CITY PLANNING COMMISSION

B. Plan Review for a 53,000+ square foot mini-storage complex in the M-1-R zone.

LOCATION: 1414 Blair Avenue

APPLC. NO. P86-216 **MEETING DATE** June 26, 1986 **ITEM NO.** 27

SITE PLAN
 MINIMUM LOT COVERAGES
 EXECUTIVE ARCHITECTS
 1111 N. ...

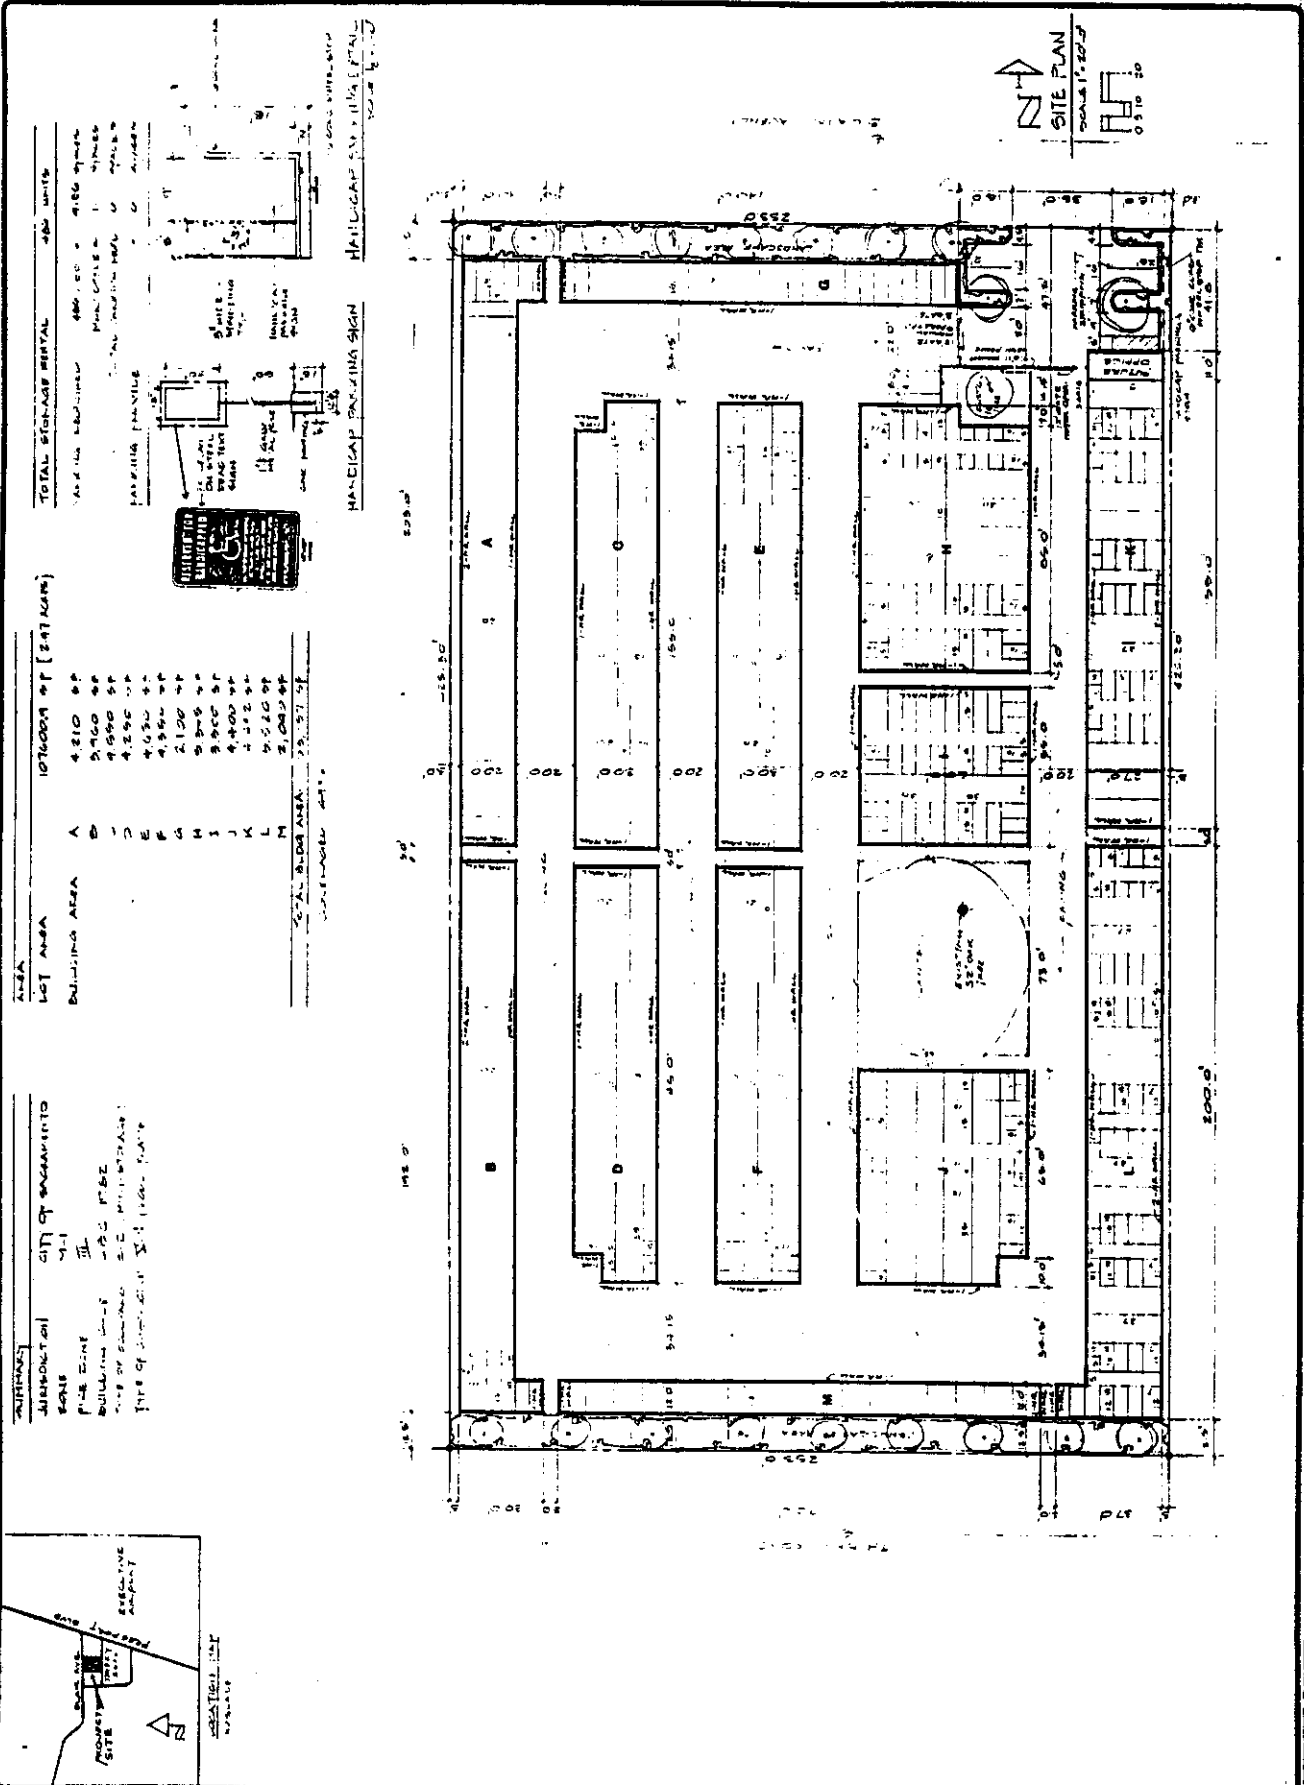
1. A portion of the parking lot is located in the required 10-foot setback area. The spaces must be relocated and indicated on a revised site plan.
 2. No trash enclosures have been indicated on the site plan. Two enclosures are required by ordinance.

3. The development plans do not indicate the location, size or number of on-site signs. A signage program must be submitted to staff for review and approval.

4. A complete irrigation and landscape plan was not submitted. A complete plan must be provided for staff review and approval.
 5. Staff is concerned with the long walls which face the public right-of-way. These walls are featureless and would be constructed with a relatively smooth stucco finish. The applicant has indicated to staff that they would prefer to soften the exterior walls by using climbing vines and other vegetation. Staff feels that the elevations are rather bleak and that the north and south walls should be constructed with a textured finish with some vertical feature or column to break up the wall. The parapet wall should also extend along the full length of the north and south wall.

Buildings L and K are over existing water main. No building permit for these buildings shall be allowed until existing main is abandoned (it is anticipated that the water line will be abandoned within the next 30 days or sooner).

1. All gates and fences shall be constructed of open wrought iron. No chainlink fence shall be permitted.
2. Two trash enclosures shall be located on site. A revised site plan shall be submitted indicating the enclosure locations for staff review and approval prior to the issuance of building permits.

3. That portion of the parking lot, which is located in the 10-foot setback area along Blair Avenue, shall be relocated behind the setback line. A revised site plan shall indicate this change and shall be submitted to staff for review and approval prior to the issuance of building permits.

9. The applicant shall abandon the existing on-site water main to the satisfaction of the Public Works Department.
10. The applicant shall comply with the mitigation measures as outlined in the Environmental Determination section of this report.

11. The north and south walls of the building shall be constructed with a textured finish and include vertical features or volumns. The parapet wall shall also be extended along the entire length of the north and south wall. Staff shall review and approve the wall texture and finish prior to the issuance of building permits.
